STAFF REPORT
COMMUNITY DEVELOPMENT DEPARTMENT

HEARING DATE: March 17, 2022
 DATE: *Continued from: February 17, 2022*

SUBJECT: H-2021-0081
 Vanguard Village – MDA, RZ, PP, CUP

Street Section D

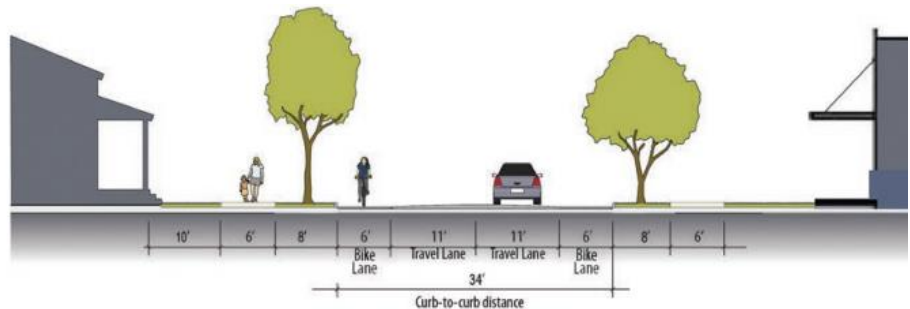
The collector streets (i.e. Coral Reef Way & Sunset Point Way) in the multi-family portion of the development in the northern 40 acres of the development should be constructed in accord with this street section. Streetlights should be placed in the dry utilities corridor on either side of the street.

Streets: Sunset Point Way and Coral Reef Way should be constructed in accord with Street Section D (residential collector street) in the TMISAP, which requires (2) 11-foot travel lanes, 6-foot bike lanes, 8-foot parallel parking, 8-foot parkways and minimum 6-foot wide detached sidewalks (see pg. 3-21 and 3-23). Streetlights should be placed in the dry utilities’ corridor on either side of the street. **The plat should be revised consistent with Street Section D.**

parkways with streetlights at a pedestrian scale and minimum 6-foot wide detached sidewalks (see pg. 3-20, 3-22, 3-23). The Applicant proposes a modification of the street section with (3) 11-foot travel lanes, on-street parking between the Williams pipeline and the eastern boundary of the site, 8-foot wide parkways and 10-foot wide detached sidewalks/pathways in lieu of bike lanes, which is required by ACHD. Staff is supportive of this change.

- c. Depict street sections for Sunset Point Way and Coral Reef Way consistent with Street Section D in the TMISAP (see pg. 3-21).
- d. Depict street sections for Vanguard Way and Umbria Hills consistent with Street Section C in the TMISAP with a modification that allows (3) 11-foot travel lanes, on-street parking between the Williams pipeline and the eastern boundary of the site, 8-foot parkways and detached 10-foot wide sidewalks/pathways in lieu of on-street bike lanes as required by ACHD. Streetlights are required at a pedestrian scale (see pg. 3-20, 3-22, 3-23).

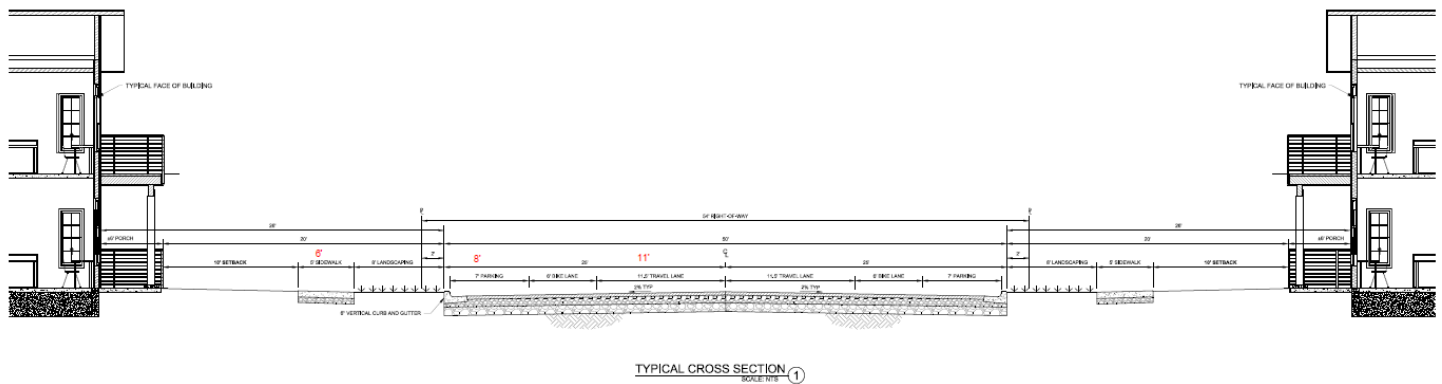
Building Elevations (UDC [11-3A-19](#) | [Architectural Standards Manual \(ASM\)](#) | [TMISAP](#)): Conceptual building elevations were submitted for the proposed apartment, flat and townhome-style multi-family and clubhouse buildings as shown in Section VII.D.7. Building materials consist of vertical and horizontal hardie plank siding in grey, green and wood colors with cedar posts and beams and asphalt shingles.

Per the TMISAP for MHDR designated areas, the design of residential buildings should incorporate street-oriented and human-scale design and be located as close to the property line as possible to create a consistent edge to the public space and make streets more friendly and walkable. The closest the structures are allowed to be per UDC [Table 11-2A-7](#) is 10-feet from the back of sidewalk as proposed in the cross-section below with the collector street buffer placed in an easement.

Structures should incorporate traditional neighborhood design. Front porches with parking behind the buildings are desired. Streetscapes with landscaped parkways with trees between curbs and sidewalks, street furniture and view corridors are key. Primary facades should include an entry into the building; entries should be located so as to provide direct access from adjacent public spaces, streets and activity areas as proposed. **Where primary facades face a designated public space and another faces a parking area designed to serve that structure such as proposed, both facades should be designed and detailed as primary facades and both should have prominent usable entries.**

3. Proposed Conceptual Development Plan

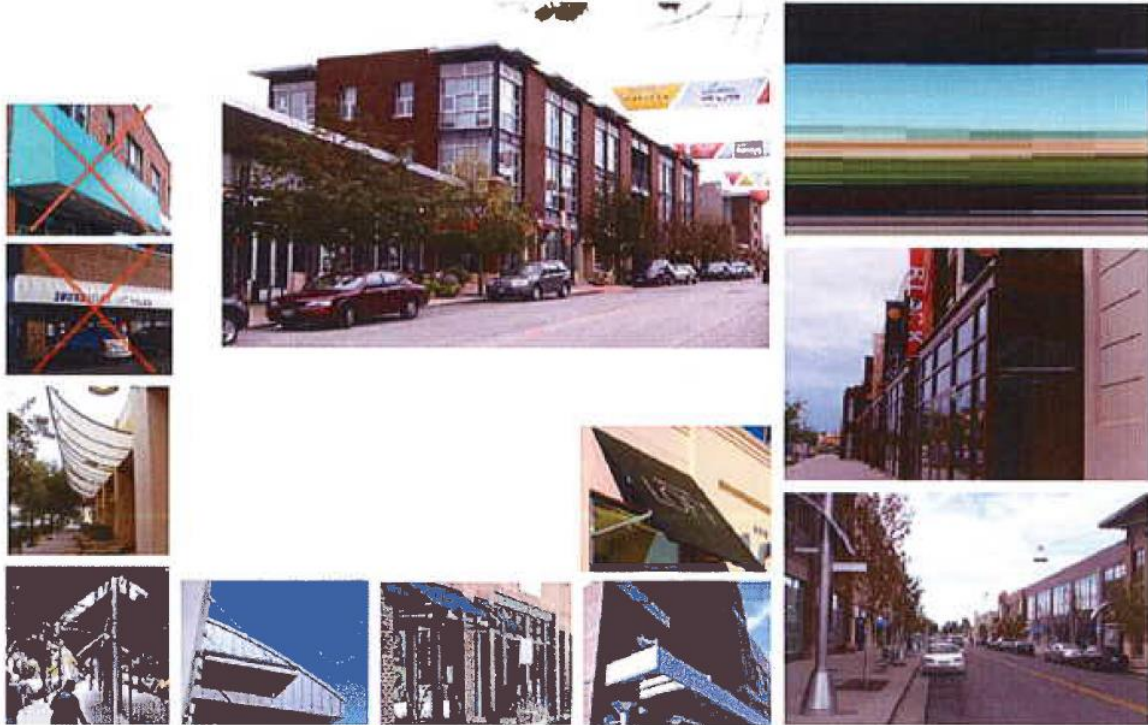
A new conceptual development plan is included in Section VII.A.3 for the proposed development and new recommended provisions for the agreement are included in Section VIII.A.1 based on the analysis of the project below and applicable UDC and TMISAP provisions. Some of the existing DA provisions that are still applicable are also recommended to be included in the amended and restated DA.

- a. Development of the subject property shall be generally consistent with the site plan, qualified open space exhibit, site amenity exhibit, pedestrian circulation plan, preliminary plat, phasing plan, landscape plan and conceptual building elevations submitted with the applications contained herein.

1. Site Plan (dated: 10/6/21)

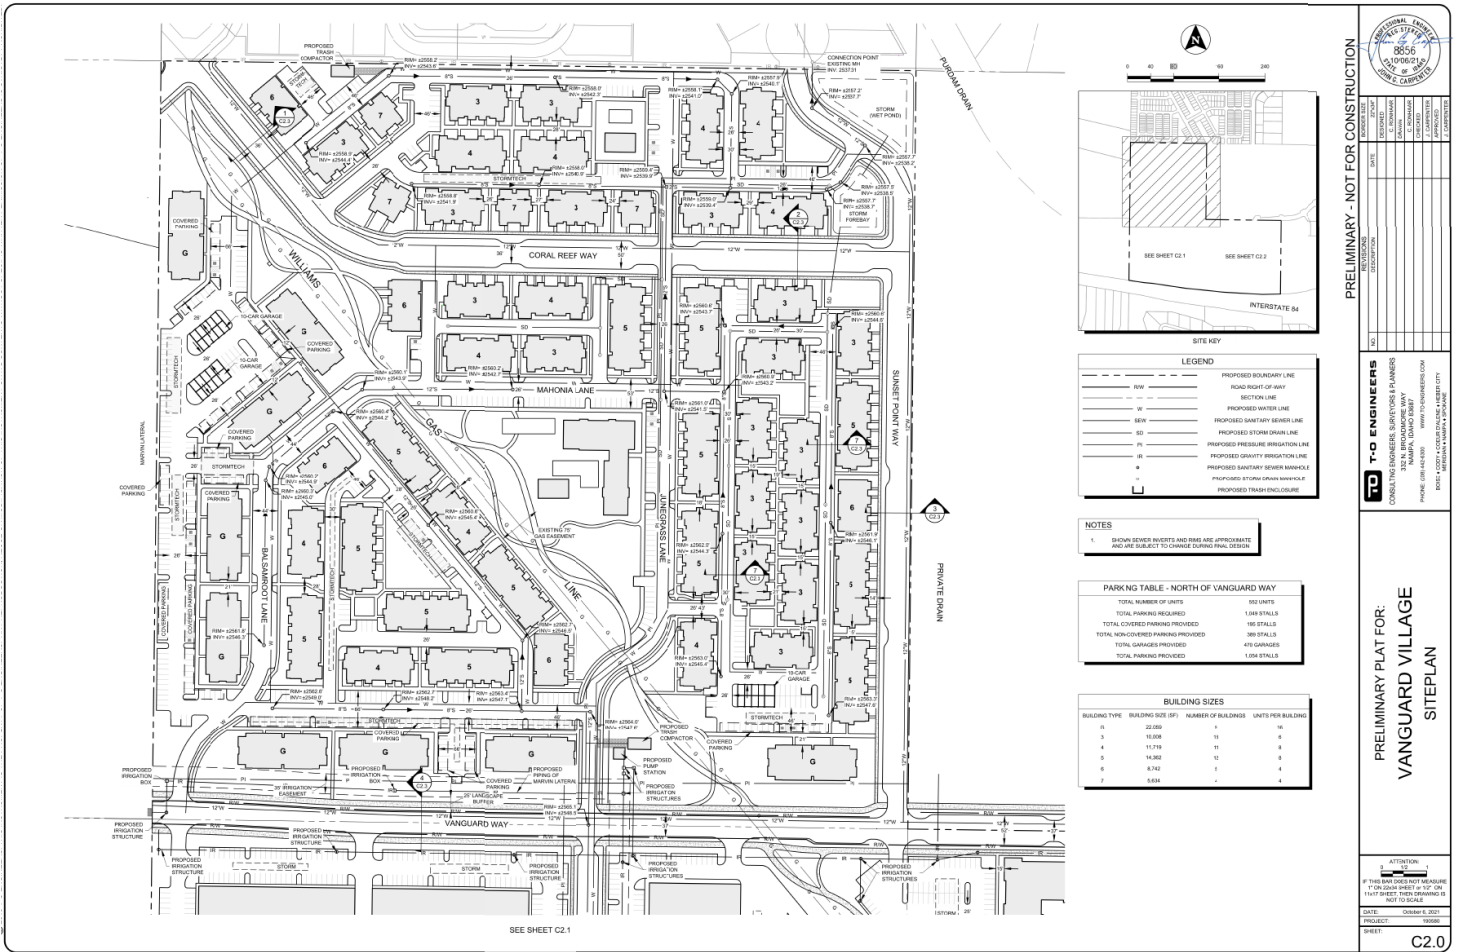
Nine (9) garden-style apartment buildings containing a total of 216 units and 51 flats and townhome-style buildings are proposed containing a total of 336 units with a mix of 1-, 2- and 3-bedroom units. See site plan and associated exhibits in Section VII.D.

- 1.10. It is unclear by the provided plans how buildings will be served and how fire protection will be provided. An additional water loop around the buildings might be required to provide fire flow. A complete water plan will be required to be submitted and reviewed by Public Works Engineering before any final plat is approved.

- c. Depict the location of the property management office, maintenance storage area, and central mailbox location (including provisions for parcel mail) on the site plan that provides safe pedestrian and/or vehicular access and the location of the directory & map of the development at an entrance or convenient location for those entering the development as set forth in UDC [11-4-3-27B.7](#).
